5 DESCRIPTION OF PROPOSED EXPANSION

5.1 PROCESSING

Figure 5.14 Conceptual water circuits for the expanded operation

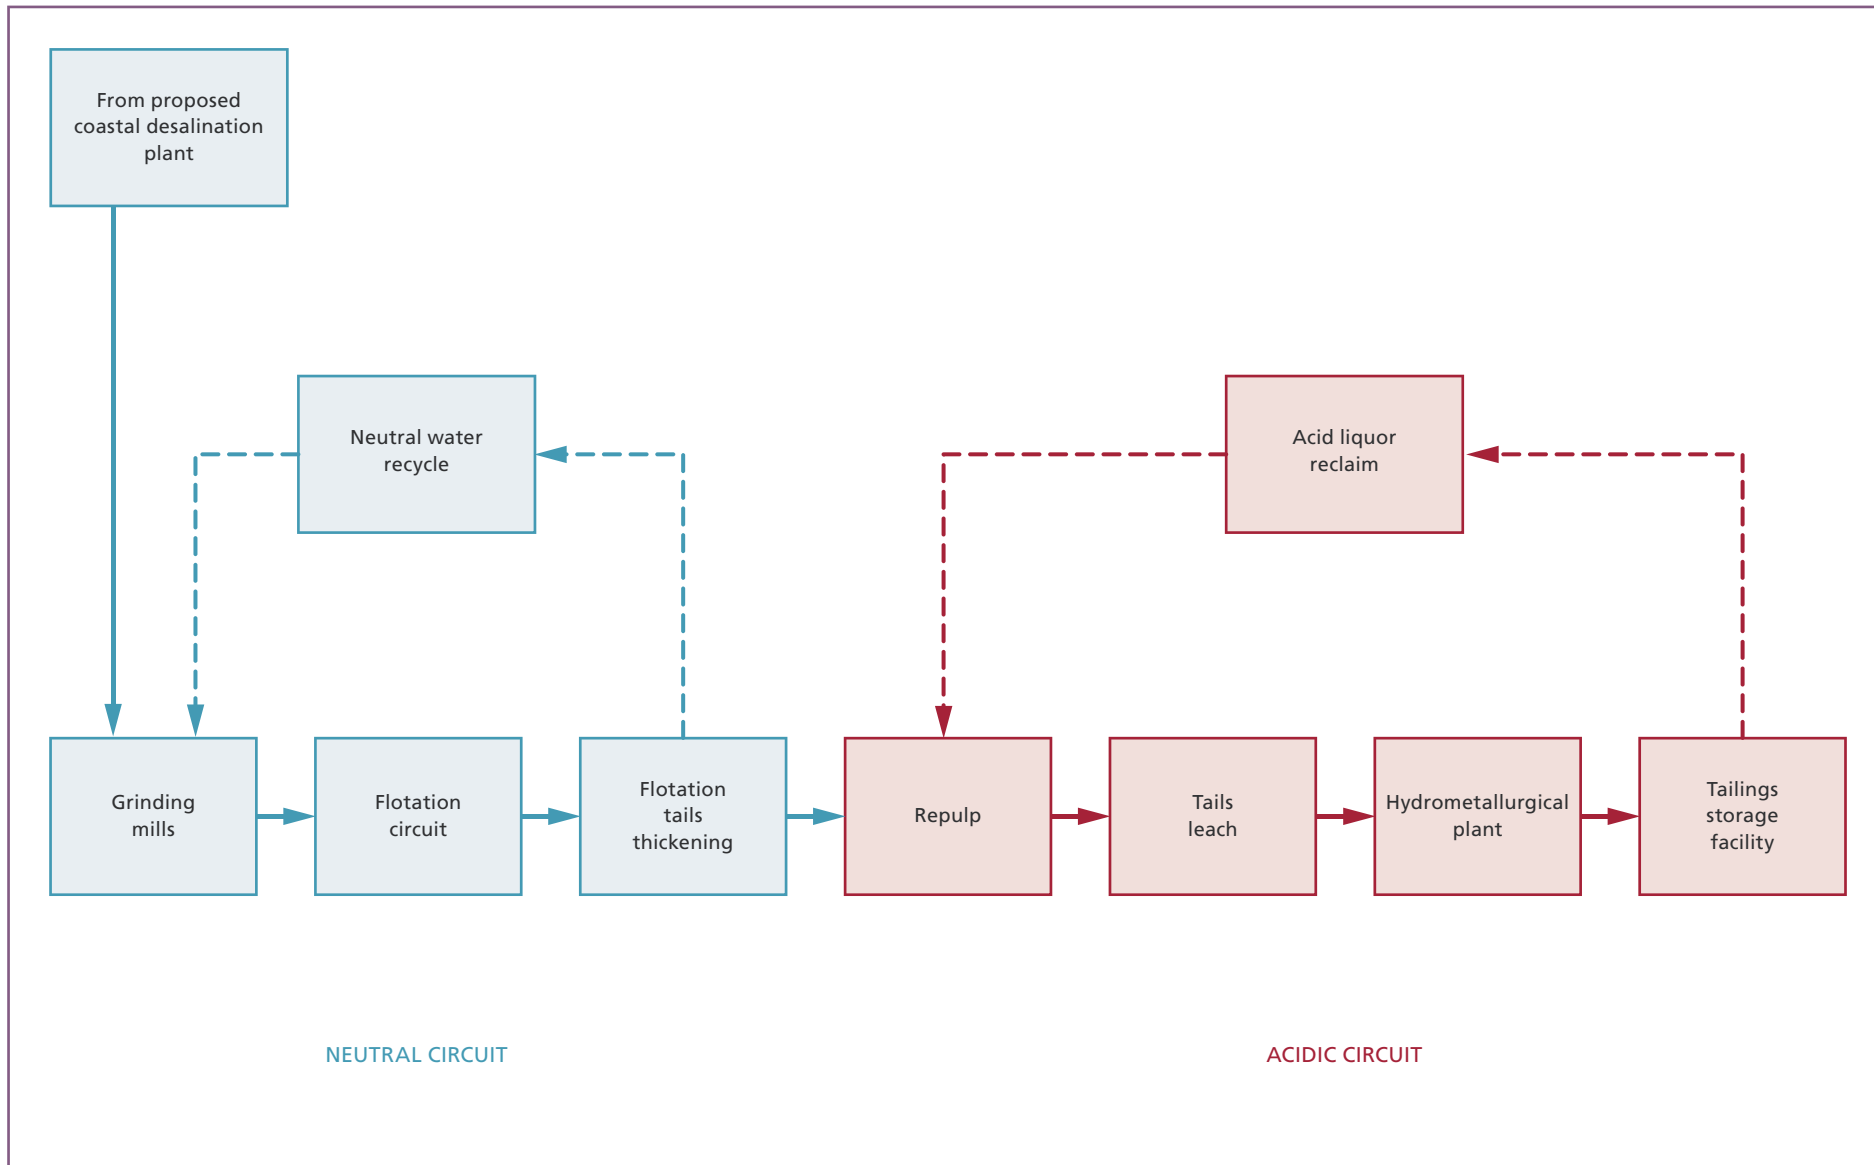
Questions were raised regarding the quality and quantity of water required to undertake metallurgical processing for the expanded operation, and the opportunities for implementing water reuse and recovery projects to reduce water demand.

The water circuit for the expanded operation comprises two components or circuits: acidic water and neutral water. The separation of these two circuits is fundamental to creating the necessary water demand (see Figure 5.14 of the Supplementary EIS). Section 5.5.4 of the Draft EIS provided details of the new flotation tails thickening stage added to the concentrator process. This allows a significant proportion of the neutral water used during the grinding and flotation stages of the process to be separated from the flotation tails material using a series of deep cone thickeners, which thicken the slurry to about 65–70% solids. The neutral water obtained during the thickening process is returned to the grinding mills and reused, with additional neutral water obtained from the proposed coastal desalination plant. The thickened slurry is transferred to the hydrometallurgical plant, where it is repulped using acidic liquor recycled from the TSF and mixed with sulphuric acid from the new sulphuric acid plants in the tails leach tanks. The degree of flotation tailings thickening is therefore intrinsically linked to both the volume of acidic liquor that can be returned from the TSF and desalinated (neutral) water used in the concentrator plant. Further investigations into maximising the potential thickening efficiency would continue to be progressed through detailed design and into operations.
